**CITY OF DOVER, DELAWARE
PLANNING COMMISSION
Monday, December 18, 2023 at 7:00 PM**

6. SB-23-03 Revised Stonebrook East Planned Neighborhood Design at McKee Road and W. Denneys Road - Public Hearing and Review of a Revised Subdivision Plan to increase the number of townhouses from 87 to 103 townhouses (increase of 16 townhouse units) and to decrease the number of garden apartment units from 168 to 138 garden apartment units (decrease of 30 units). This development known as Stonebrook East Planned Neighborhood Design (PND) proposes 241 dwelling units, recreational areas, open space, and stormwater management areas. The property is zoned RM-1 (Medium Density Residential Zone) and approved as a PND (Planned Neighborhood Design Option). The site is on the northeast corner of McKee Road and W. Denneys Road. Property Address: intersection of McKee Road and West Denneys Road. Property Owners: Hanae Harmony Properties and Stonebrook East 168 LLC. Tax Parcels: ED-05-057.03-01-01.00-000 to ED-05-057.03-01-92.00-000. Council District 1. *PND - Alternative Design Standards Requests: Townhouse Units – To permit a minimum lot width of 20 feet and reduction of minimum lot area. Garden Apartment

DATE: NOVEMBER 03, 2023
SCALE: 1" = 80'
PROJECT NO. 13053.CA
SHEET: C-301

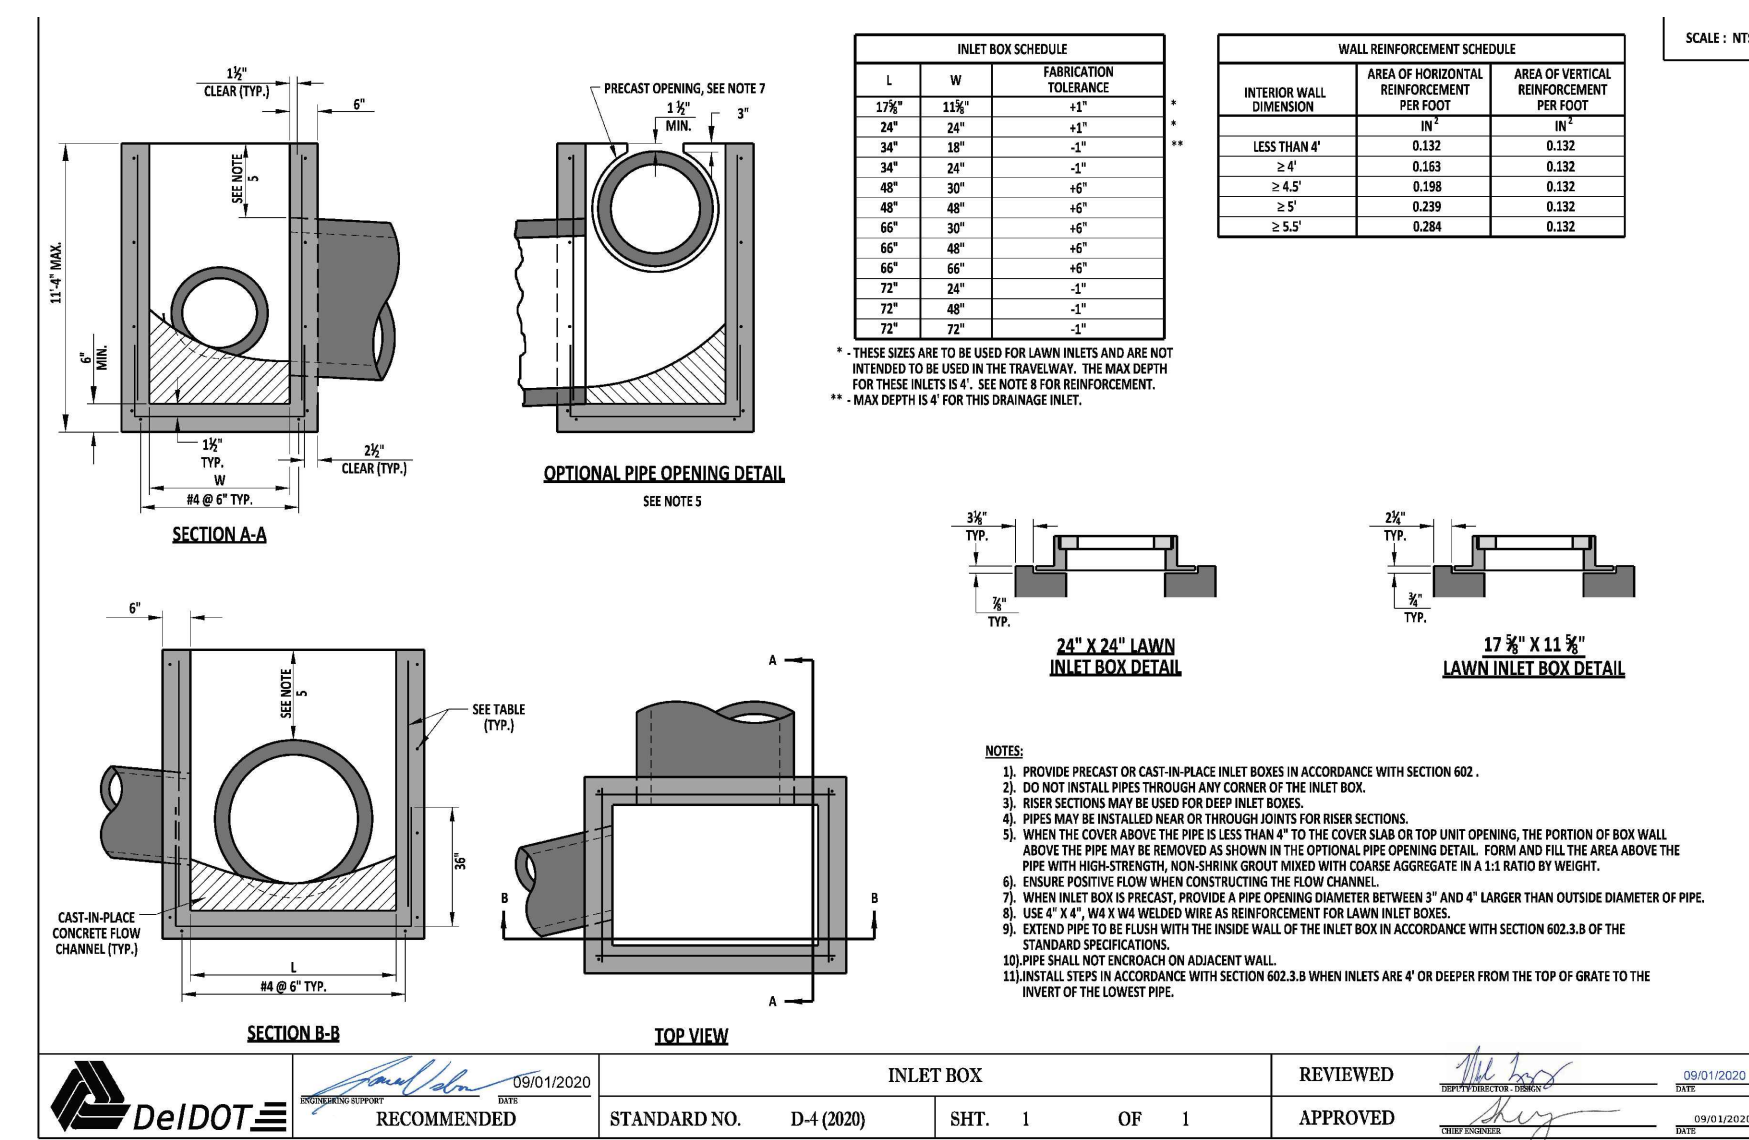
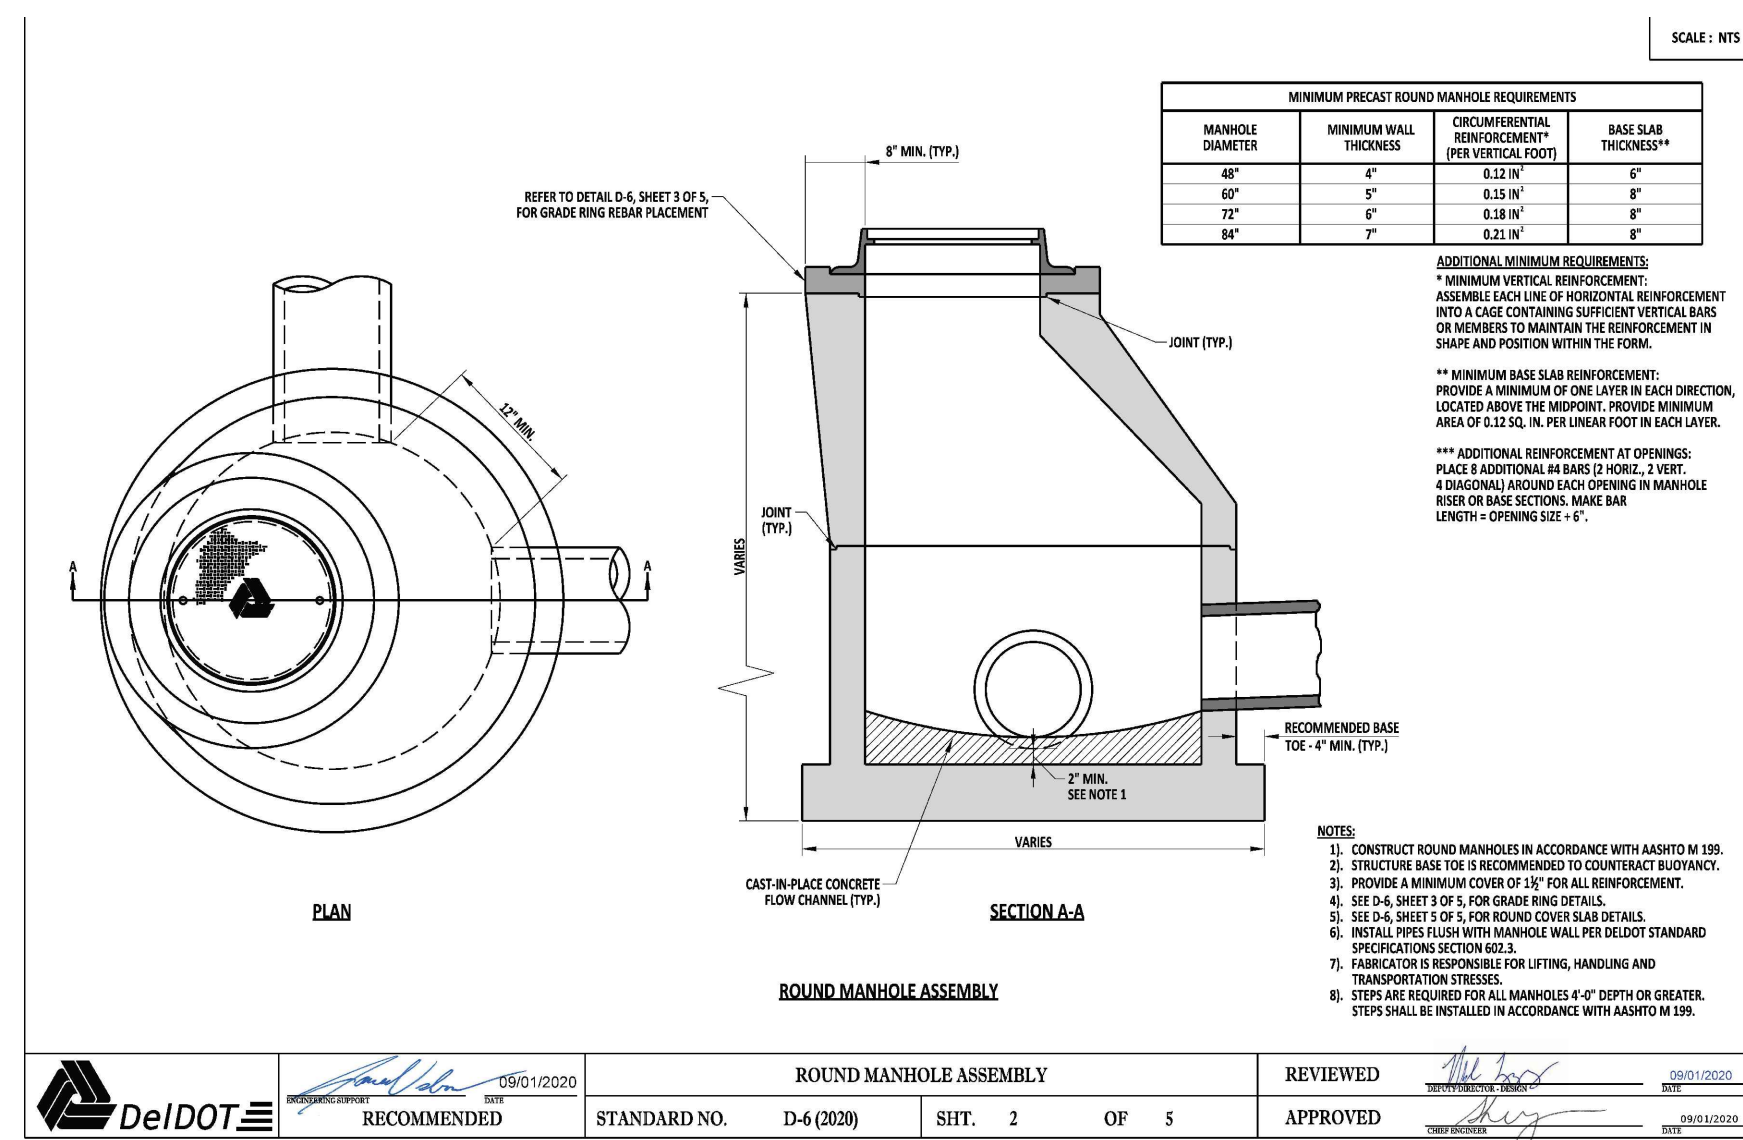
- 9) Sheet C-301 – Utility Plan:
 - a. Identify if Community Garden has a water source.
 - b. See Department of Water & Wastewater comments regarding potential Water Tank reservation area.

- c. Check General Utility Notes #9 and 10 as these may only apply to the apartment complex lot.
- 10) Sheet C-601 – Signage and Striping Plan:
 - a. Striping and Signage Construction Notes items are not labeled on this sheet but may be shown in large scale plan sheets series.
